Re: Starbucks/Panda Site Engineering Plan Review

This letter is in response to the review comments dated March 6, 2023.

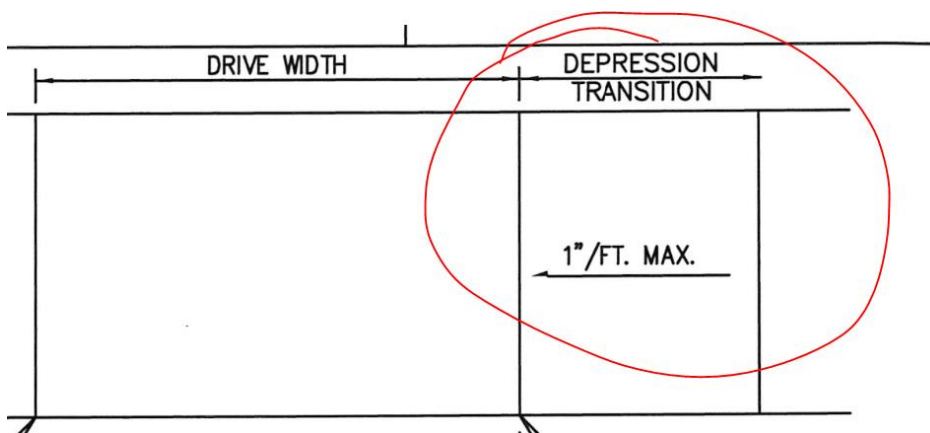
8. Show cross section of work in right of way including pavement repair, new curbing, sidewalk, etc. Label offsets from centerline and r/w line.

Excel Response: Cross section views have been added to sheet C1.2B for reference. Pavement section detail added to C2.0.

Red Marks (#1)

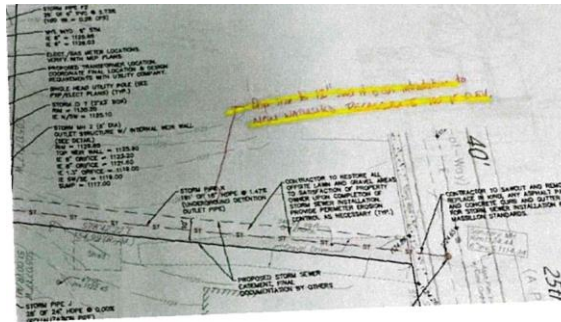
24. Reduce the size of the storm outflow pipe to 12-inch diameter and recalculate the routing. Since this is sending the water to a pipe that has not previously received water from this location, we do not want 18-inch pipe coming in. SEE redline #1.

Excel Response: This outlet pipe has been reduced to 12" as requested.

Red Marks (#2)

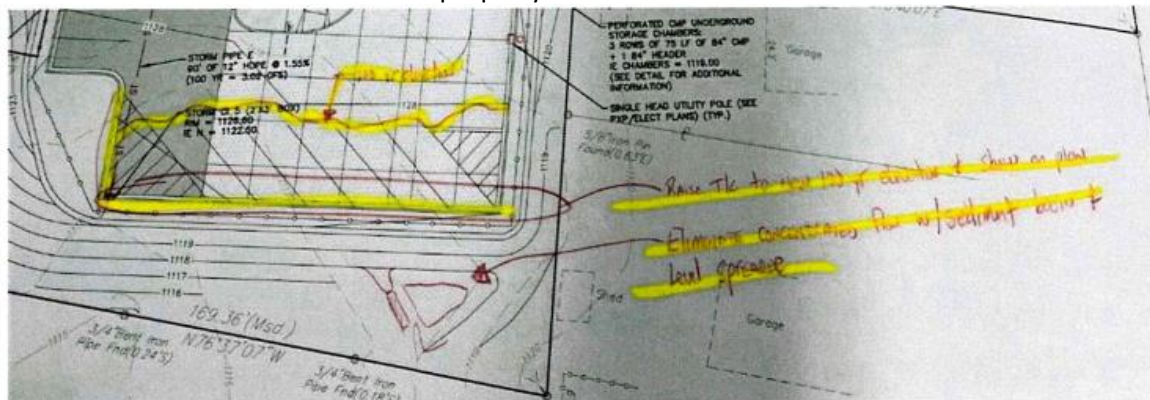
25. Based on the new 100-year elevation, adjust the top of curb elevations to contain the water, and show the new elevation line. SEE redline #2.

26. We cannot introduce new concentrated flow as shown, please provide a basin/level spreader to eliminate creation of ditch off property line. SEE redline #2.

Excel Response: Per Stark County volume stacking requirements, additional storage volume was added to the system. With this new storage volume in the system, the 100 yr elevation of 1124.13' is well below the onsite curb inlets and top of curb elevations.

Excel Response: A level spreader has been added at this location.
